Addendum #1 to Update #2 to the
Technical Drainage Study for

Grand Canyon Village
Las Vegas, Nevada

**SUBJECT: ADDENDUM #1 TO UPDATE #2 TO THE TECHNICAL DRAINAGE STUDY FOR
GRAND CANYON VILLAGE (DS #5398)**

**CLV COMMENT LETTER FOR GRAND
CANYON VILLAGE UPDATE #2
(DS#5398D)**

STORM DRAIN LATERAL 3
(PUBLIC)

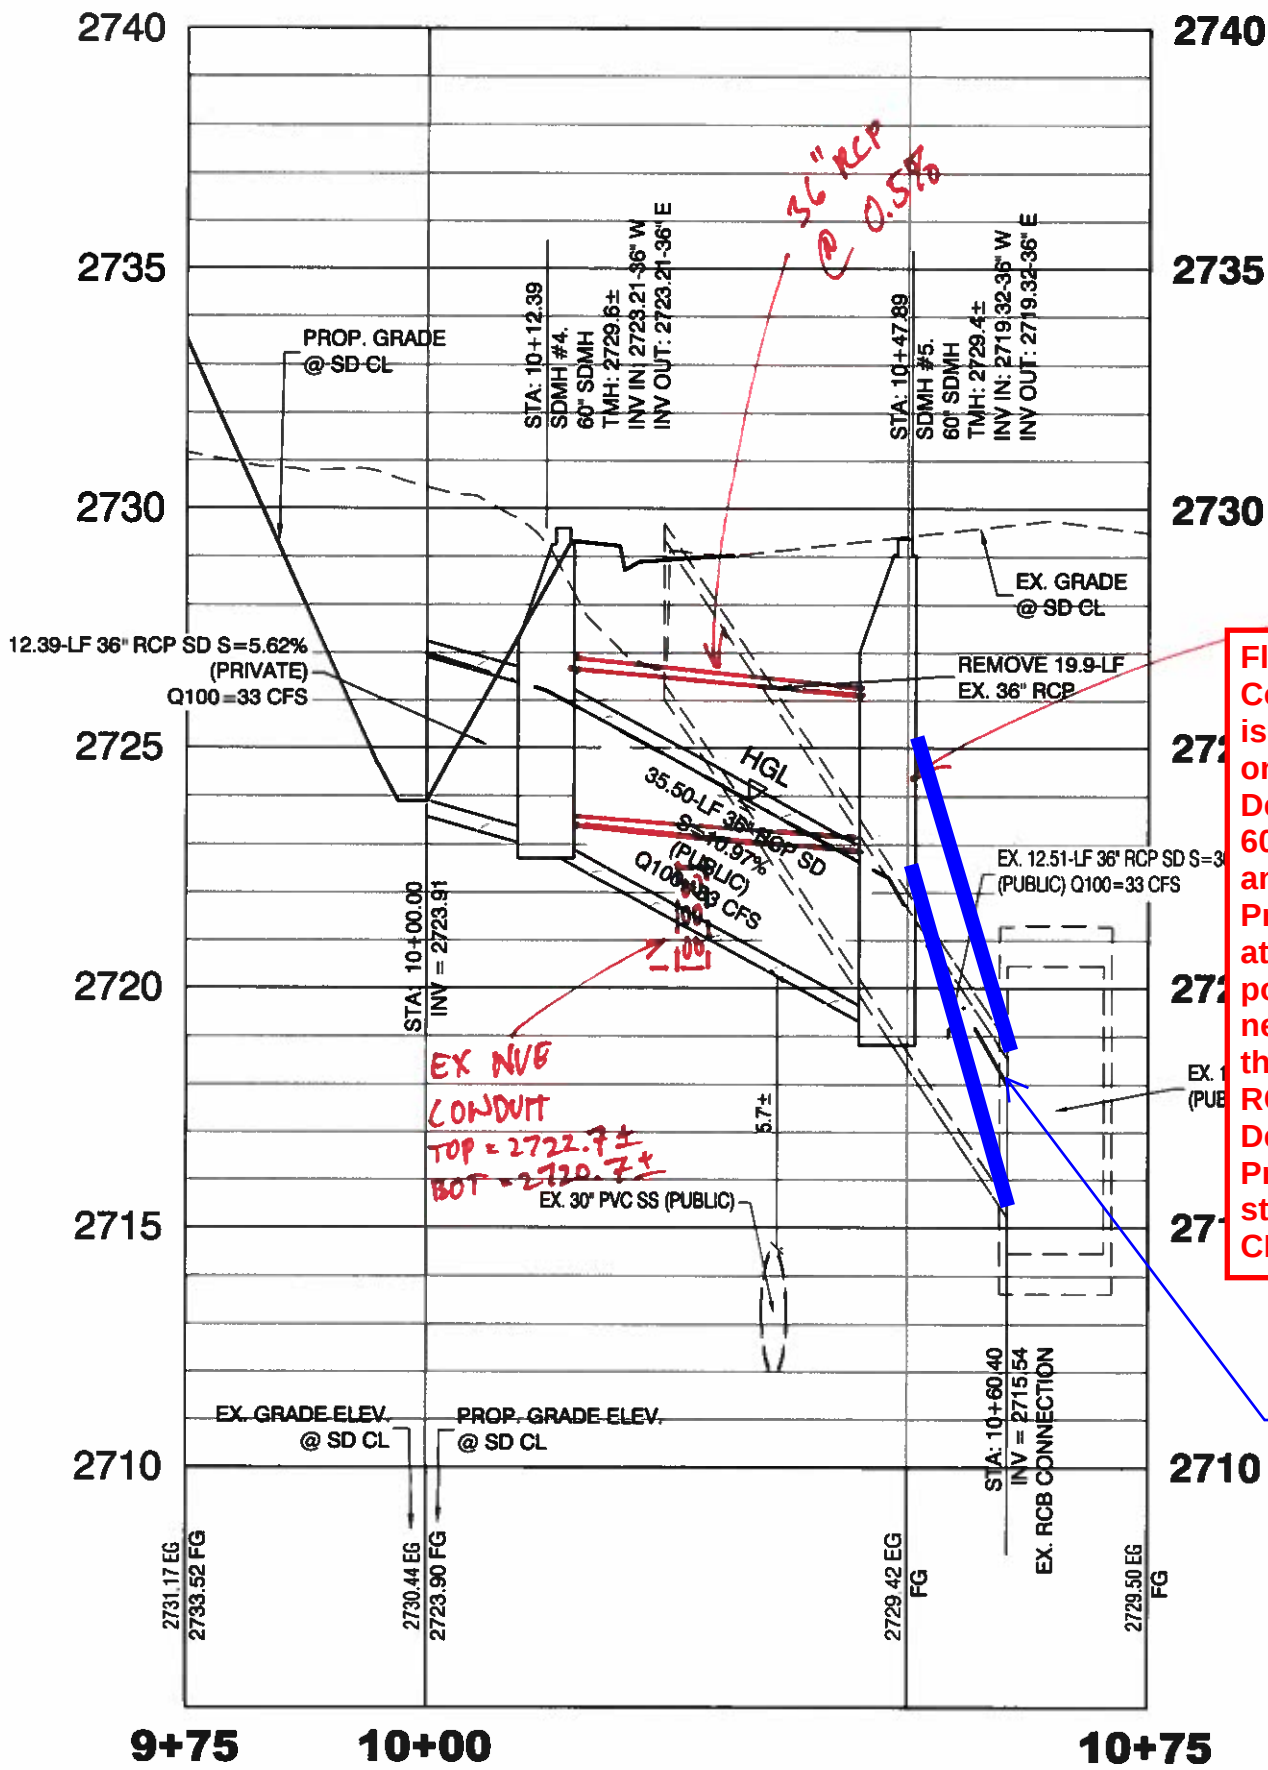
Flood Control - PBJ, 6/2/22
Concept of no Drop Manhole is much better. No Structural on the manhole, reference the Detail being used.
60" manhole with 30" cover and steps to the invert.
Provide concrete collar Detail at the new pipe penetration point into the RCB. You might need your Structural to look at the Connection detail to the RCB. Email over proposed Detail for approval.
Provide new pipe slopes. On steeper RCP connections use CLSM backfill.

if existing pipe is removed to the box and new pipe is reconnected. are structurals calcs needed?
can a collar detail be added?

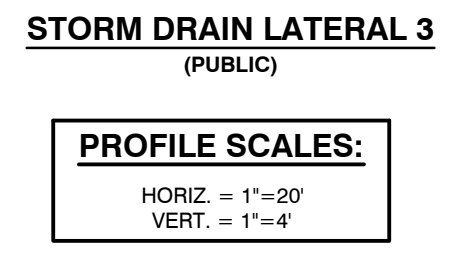
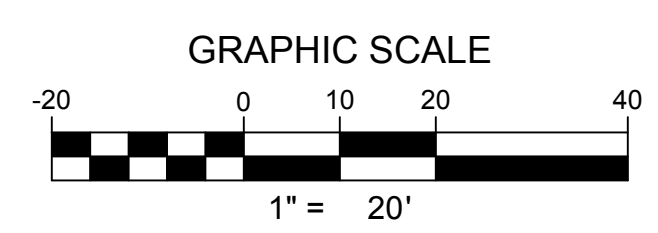
All of the 405.x drawings show the base structure of two connecting pipes without any vertical drop in elevation.

I have pdf'd you a simplified sketch of a drop structure which is different from the standard base and that's why it requires a structural design.
